### Response to Comments

PROPOSED TEMPORARY PUBLIC VEHICLE PARK (EXCLUDING CONTAINER VEHICLE) WITH ANCILLARY ELECTRIC VEHICLE CHARGING FACILITY FOR A PERIOD OF THREE YEARS AND ASSOCIATED FILLING OF LAND IN "AGRICULTURE" ZONE

LOTS 665 S.A., 666 S.A., 667, 669, AND 685 OF D.D. 90, MAN KAM TO, NEW TERRITORIES

Figure 5

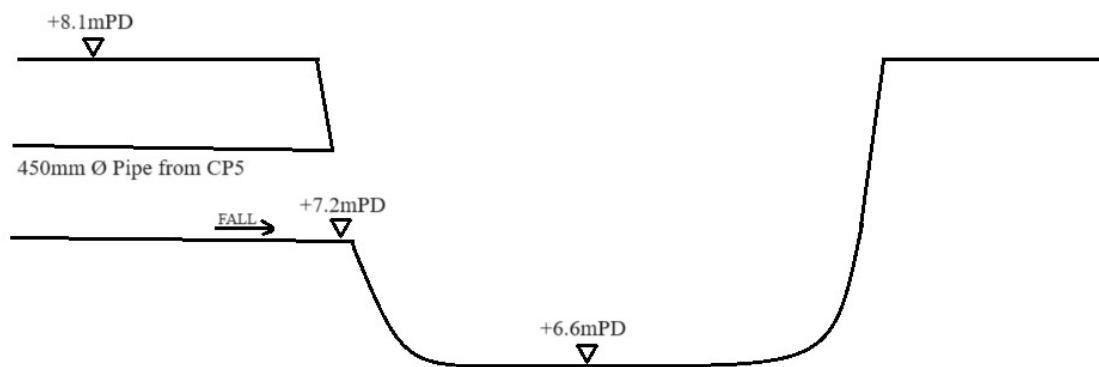
Departmental Comments	Applicant's Response
<p><b>Comments from Drainage Services Department</b></p> <p>1. For the stream along the northern boundary of the site, it seems that the cross-section shown in Figure 5 is different from the actual condition as shown in the photos. Please provide a realistic cross-section with invert level and bank levels.</p>	<p>Attached please find revised Page 8 of the drainage proposal with the revised Figure 5. Please also find the revised Figure 5, cross-section with invert level and bank levels, below for ease of reference.</p>
